Architect's Supplemental Instructions

PROJECT:
Summit Square
Apartments Phase II
 837 NW Donovan Road
 Lee's Summit, MO 64086

ARCHITECT'S SUPPLEMENTAL
INSTRUCTION NO.: 16

At the Owner's request, an addition to serve as the Parcel Storage room was added to Building 1. Additional revisions and clarifications to the scope are summarized per sheet, and reason for the change where applicable:

A3.41

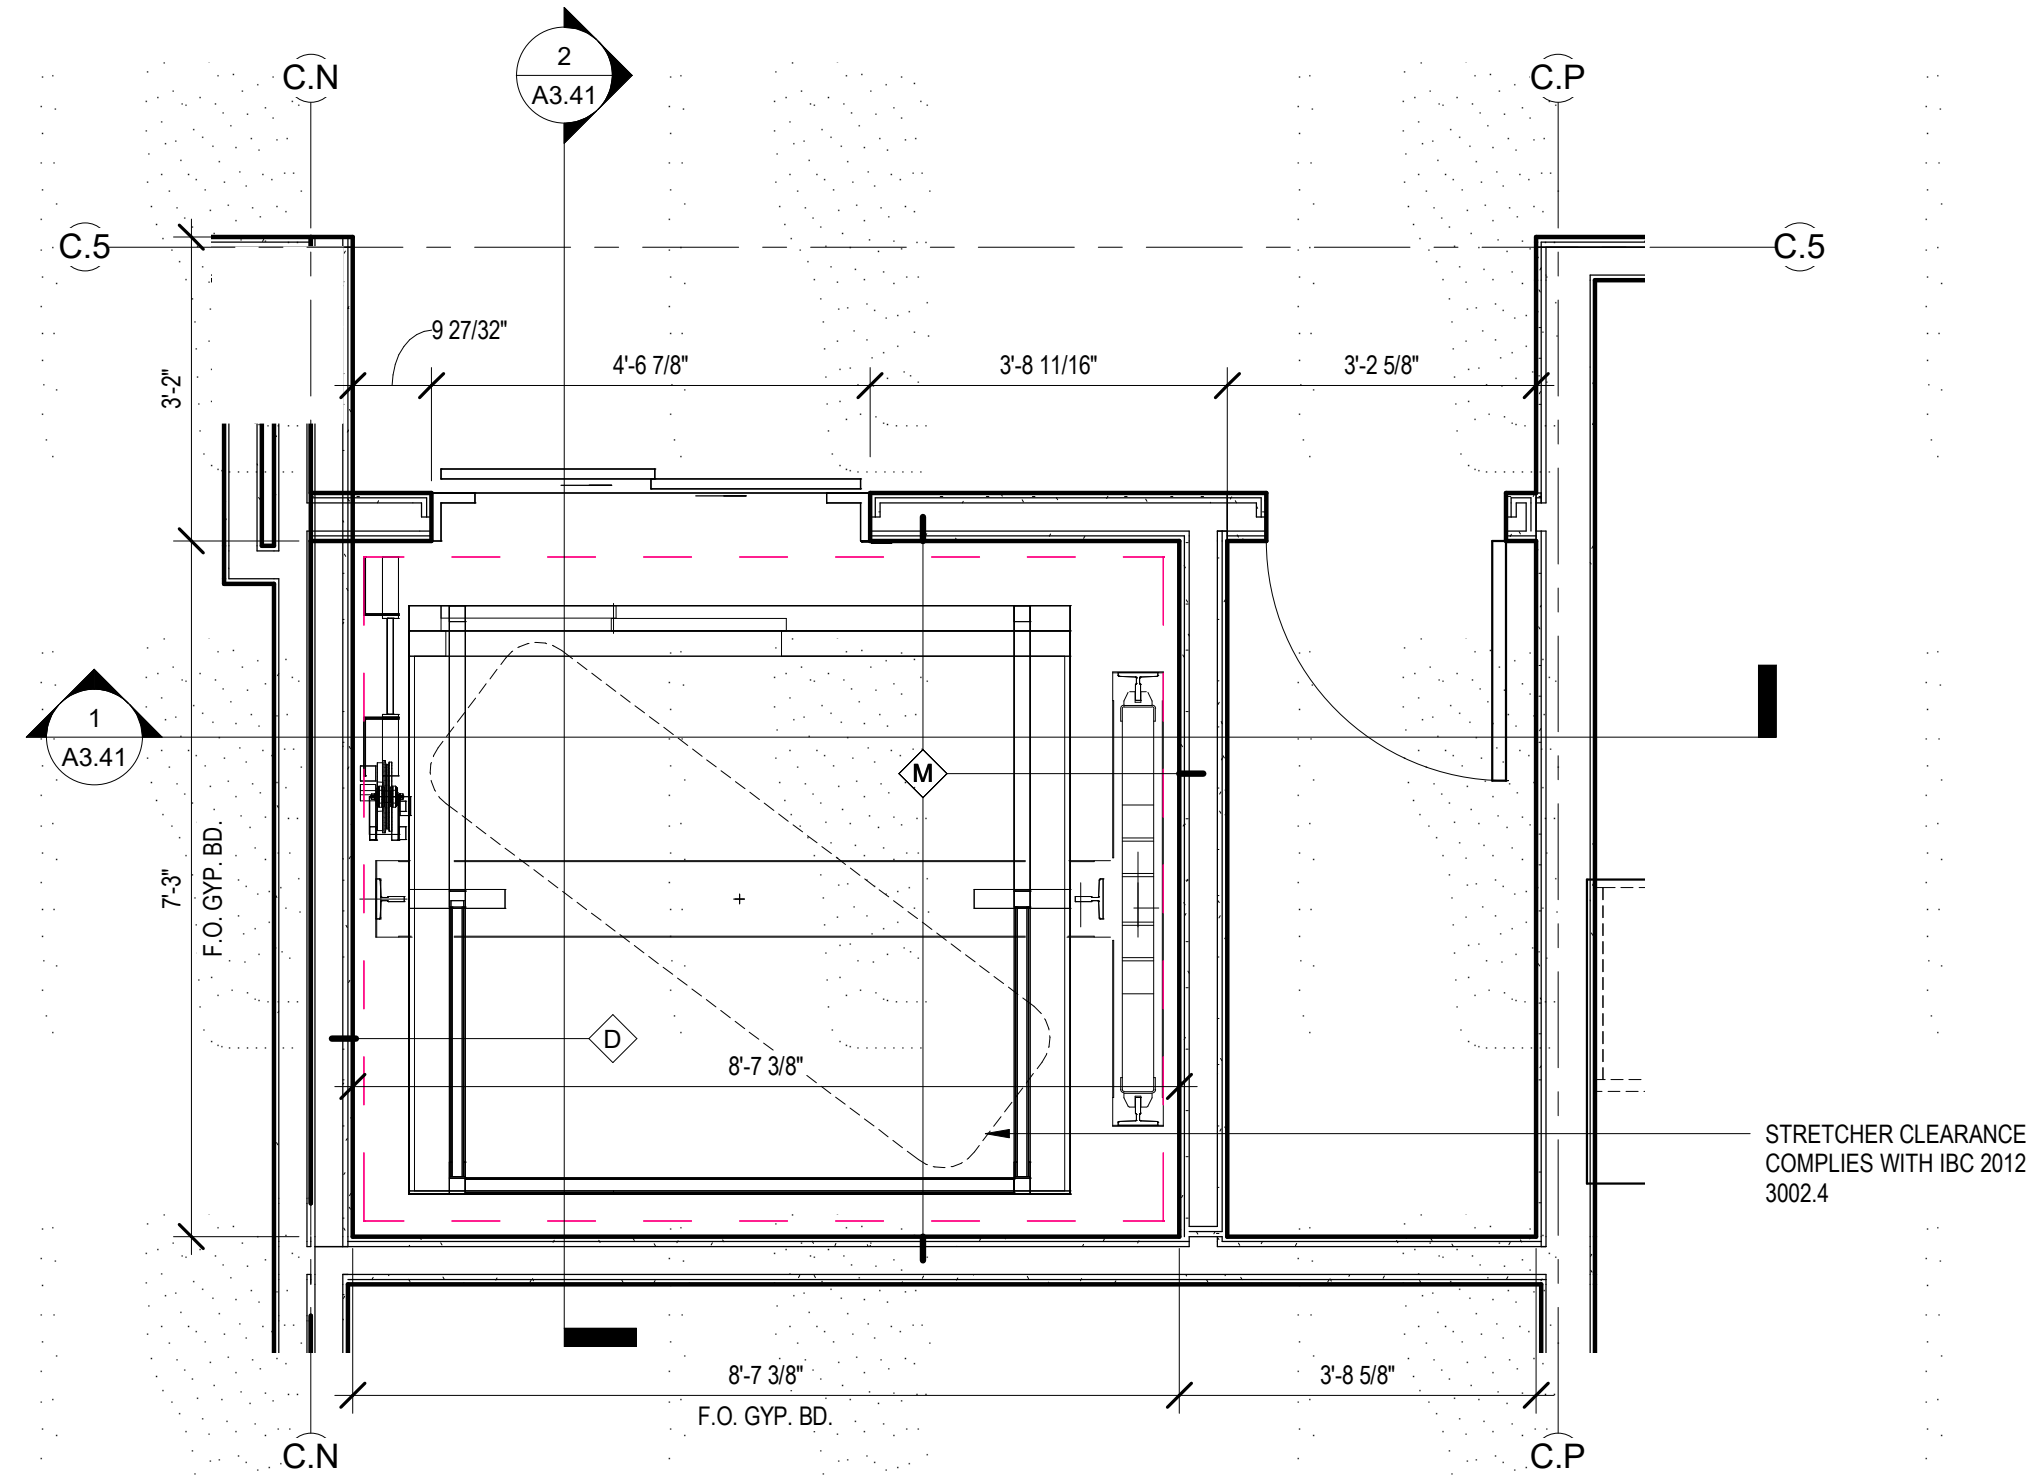
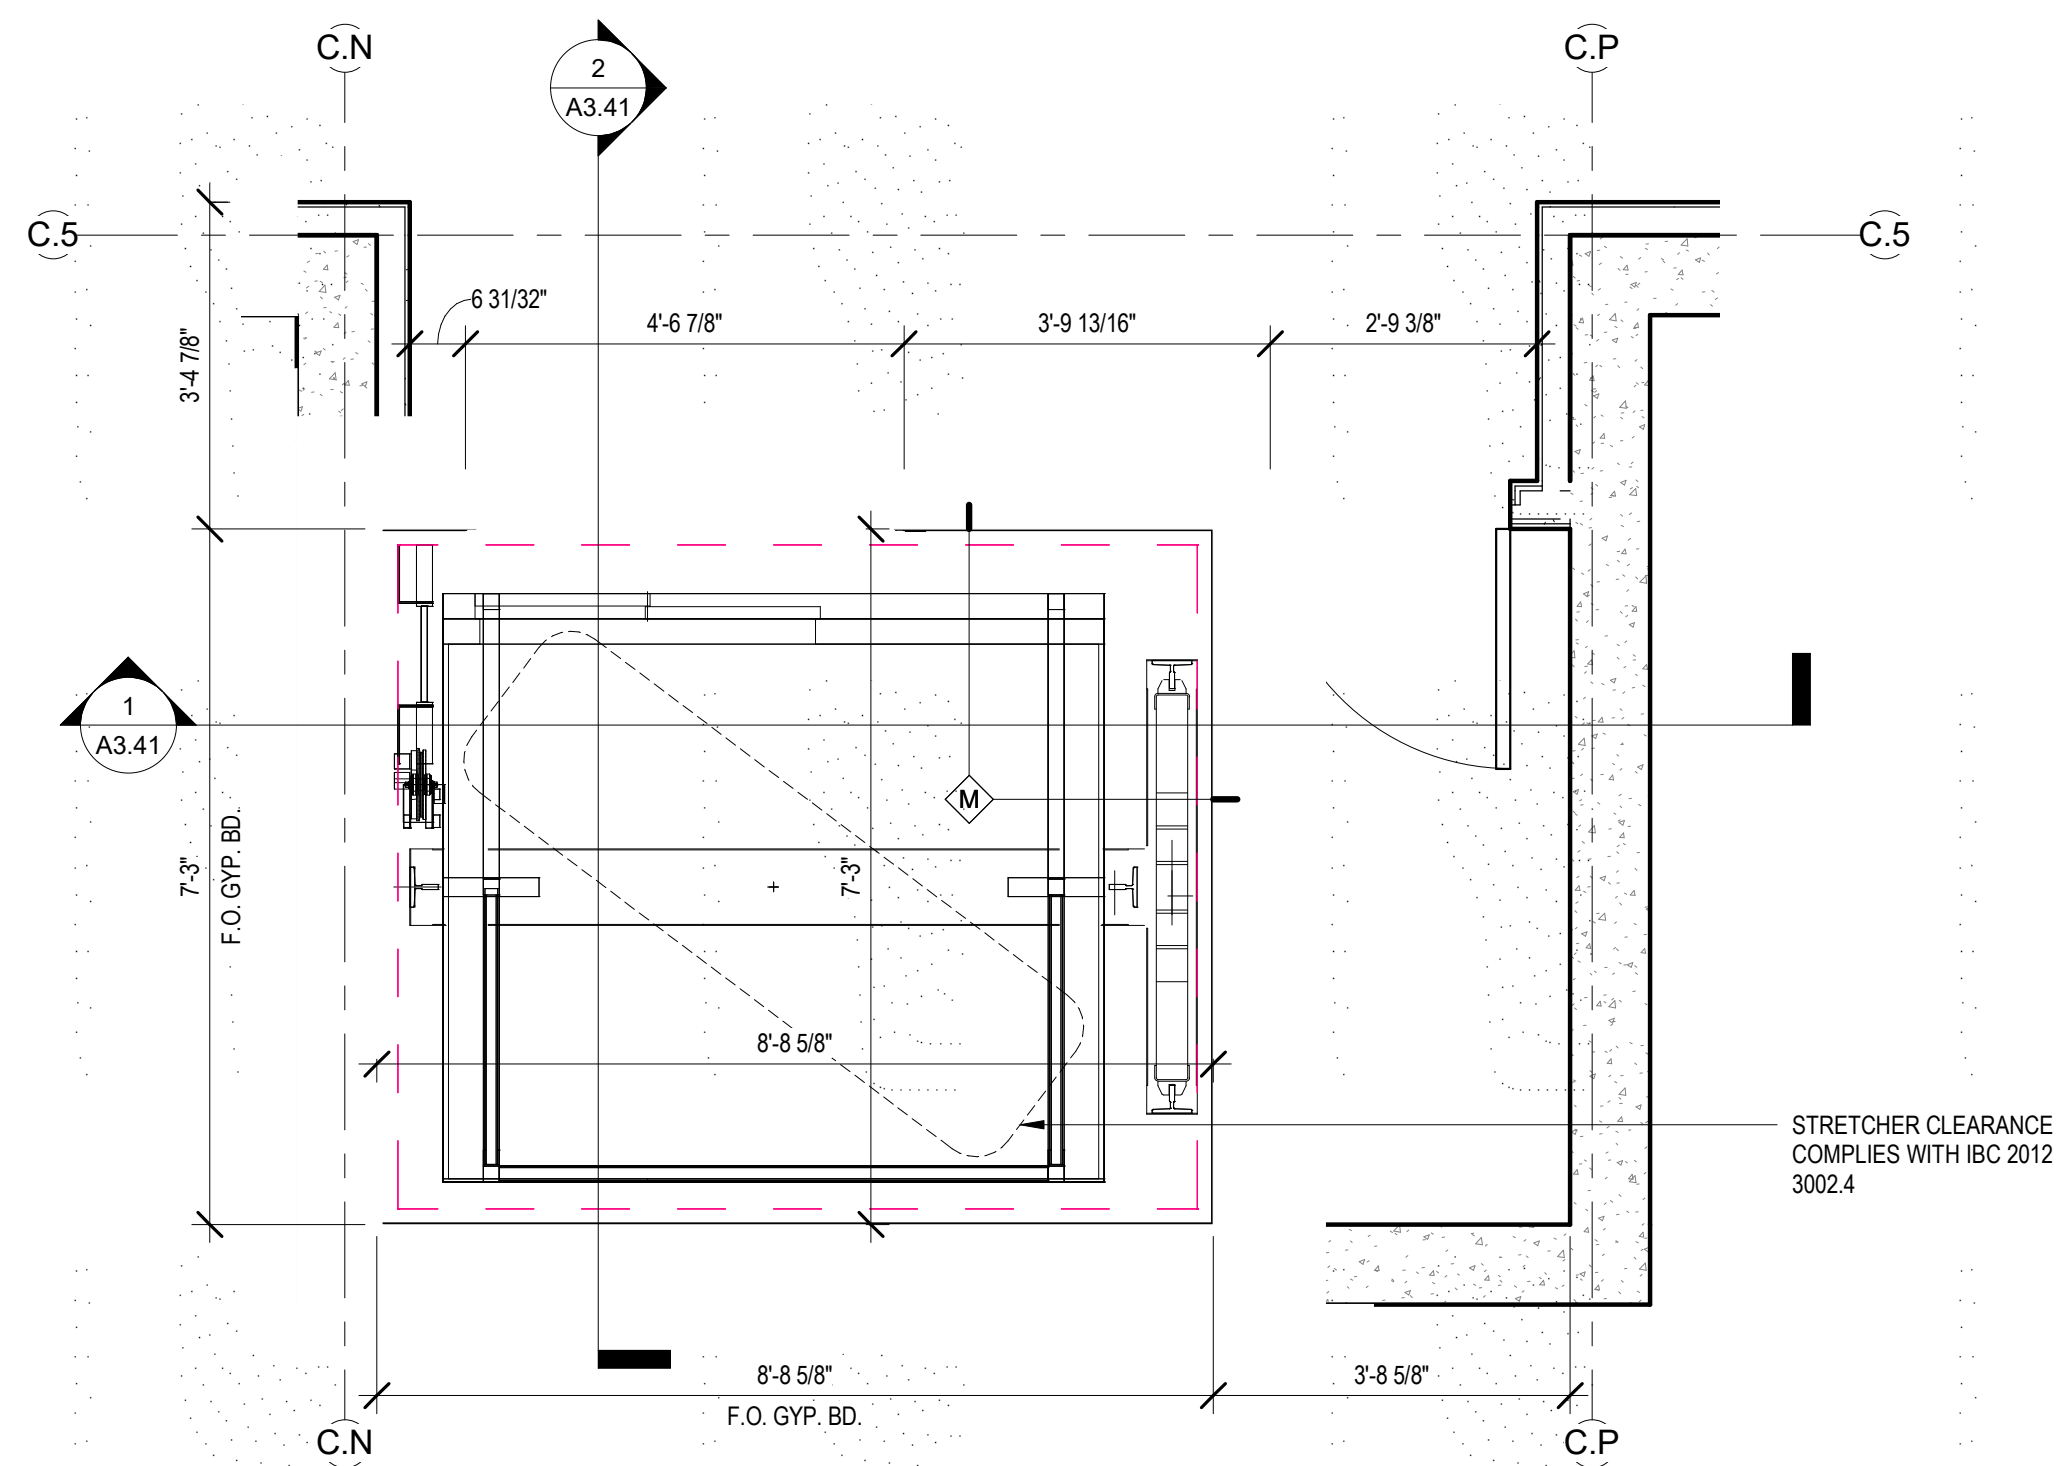
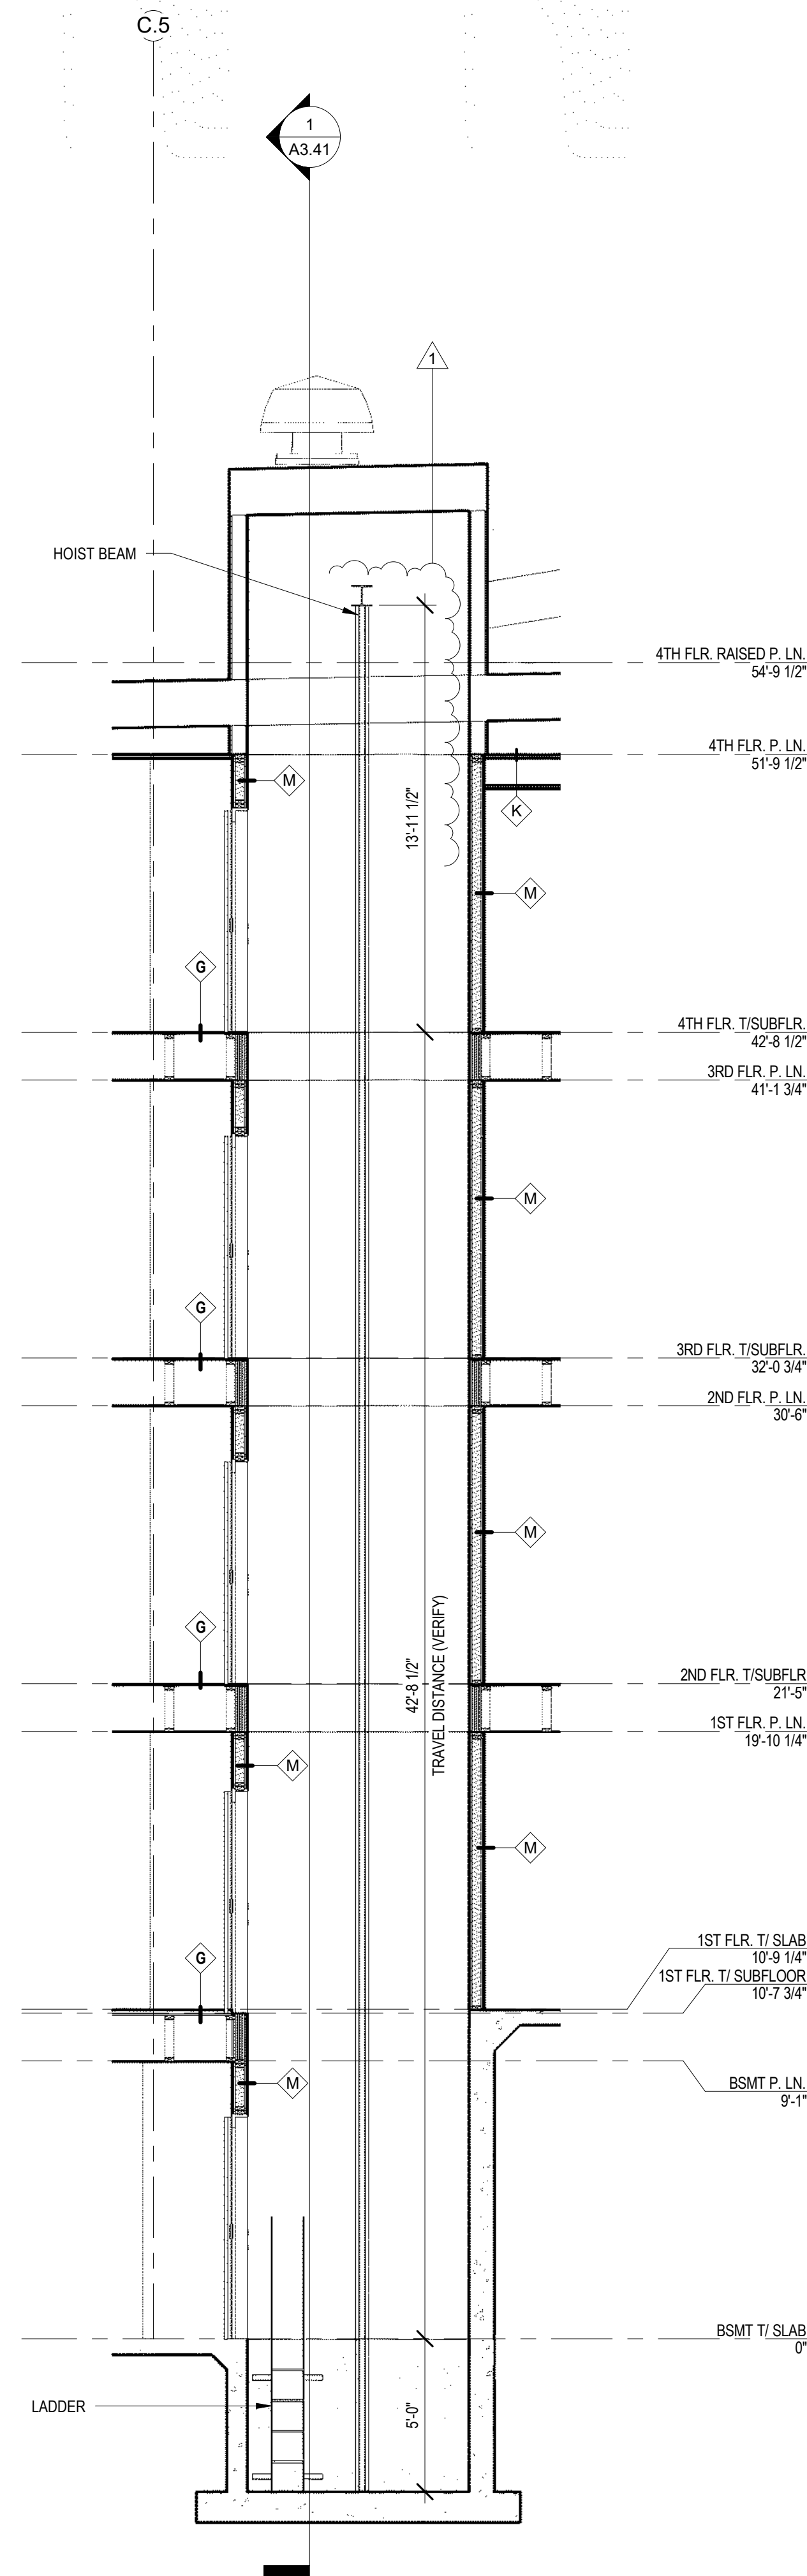
- A2.15B *Revised Elevation for Parcel Storage room addition*
- A3.40 *Document Elevator Beam Height change (as indicated on Elevator Shop Dwgs)*
- A3.41 *Document Elevator Beam Height change (as indicated on Elevator Shop Dwgs)*
